MEMORANDUM

RE: Responses - Church of the Woods Appeal; SCH No. 2004031114

Letter D – Shute, Mihaly, & Weinberger (letter dated October 8, 2020)

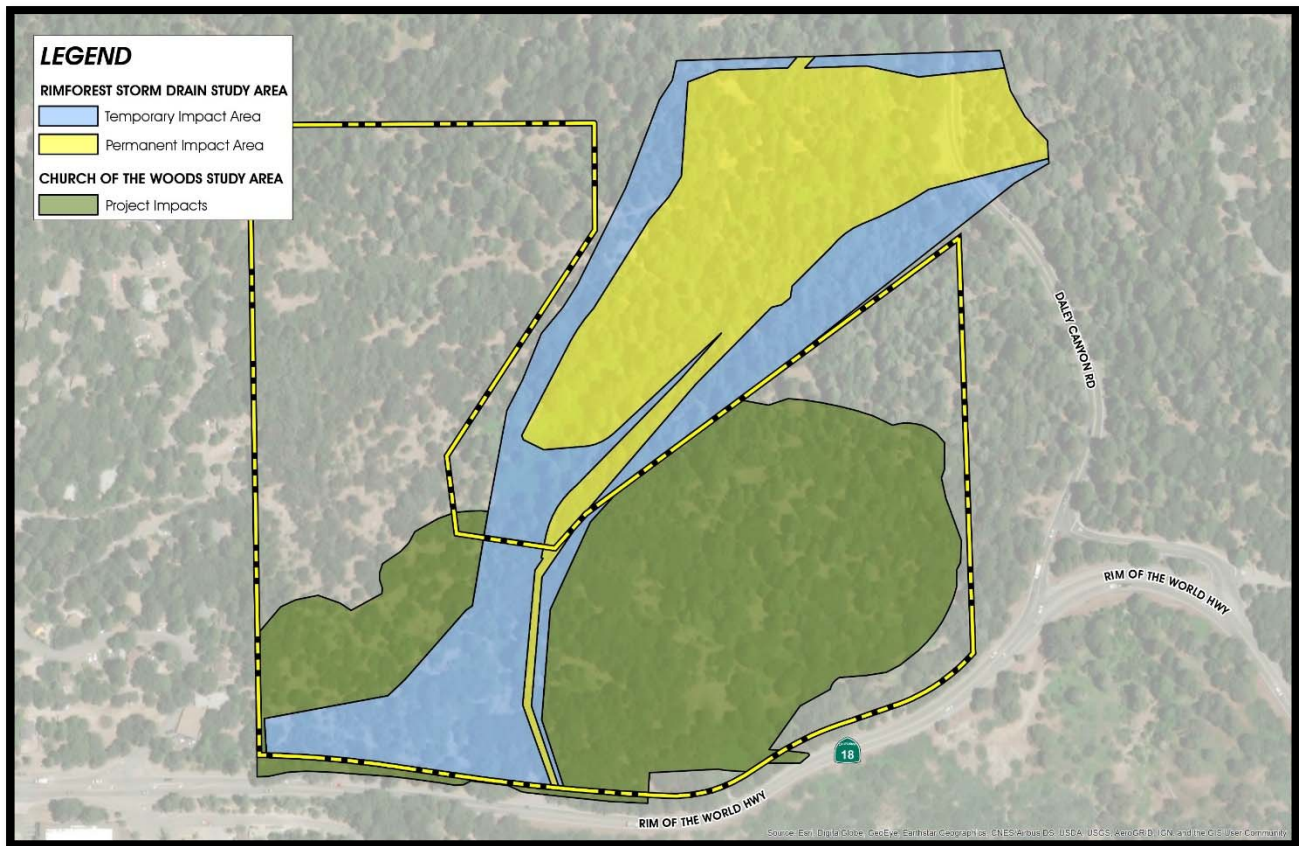
The commenter asserts that the Project's increase in impervious surfaces would cause stormwater to discharge into and contaminate Little Bear Creek. Commenter's suspicion about contamination is incorrect given the numerous mandatory regulatory requirements addressing water quality that COTW must comply with, as previously explained in Draft REIR Subsection 3.F (pp. 3.F-1 to 30), Final EIR Response to Comments 10-50, 10-64, and W (pp. FEIR-165, 171, and 438), and Responses A-7 and B-41 of the 9/29/20 Response Memo.

The County provided clarity in the Final EIR and 9/29/20 Response Memo regarding the COTW Project's relationship with the RSDP and the responsibility for mitigation of impacts. The RSDP will be implemented first and to assure that this occurs, the County placed Condition of Approval (COA) No. 37 on the COTW Project that requires the components of the RSDP to be in place that materially affect the COTW Project or property prior to implementation of the COTW Project. As shown in commenter's own October 8, 2020 comment letter, Exhibit D, Figure 1, "Changes to Project Design," the RSDP will disturb a large swath of land through the COTW Project site. The illustration provided on the next page shows the RSDP temporary impacts in blue and RSDP permanent impacts in yellow. The additional COTW disturbance footprint is shown in green, with the COTW Project boundary shown as a dashed yellow line.

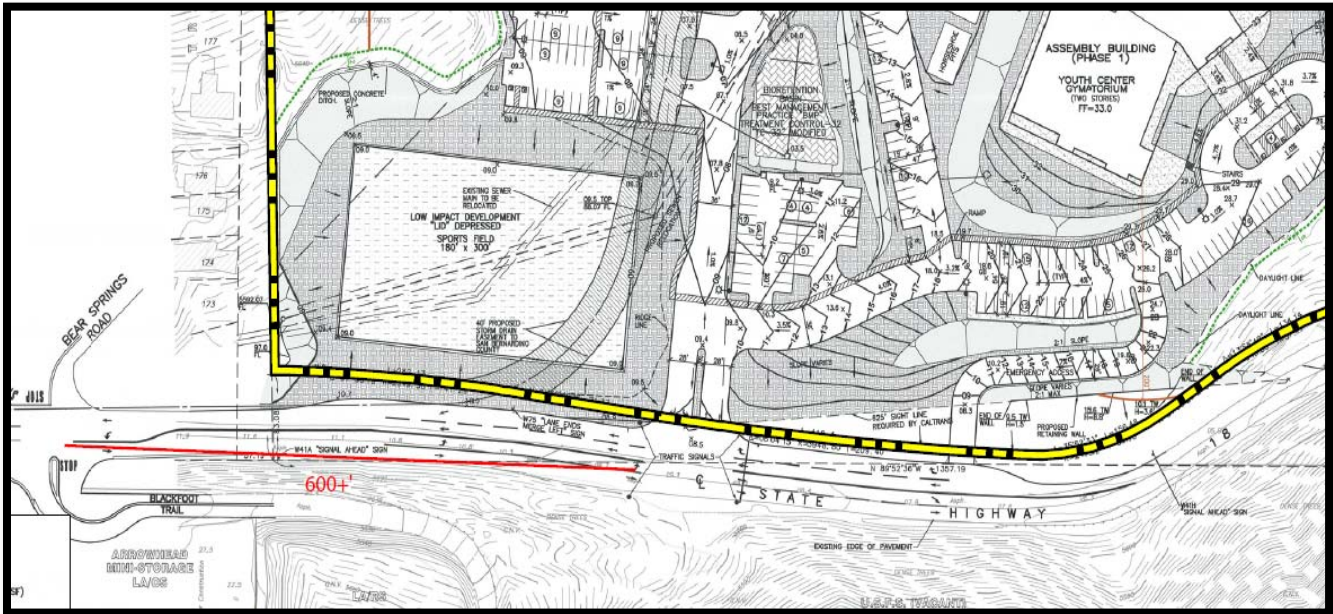
The commenter provides a list of questions that they believe should have been addressed in the Draft REIR. Questions 1, 2, and 3 address mass evacuation of the mountain area and go beyond the scope of evaluation required for the proposed Project, which entails constructing and operating a place of worship that is already serving the community in a different location. Regarding Questions 3 and 4, refer to the COTW Evacuation Plan in Draft REIR *Technical Appendix E1*, and Final EIR Responses 10-43 through 10-48 (pp. FEIR-162 to 164) which demonstrate that the COTW site can be safely evacuated.
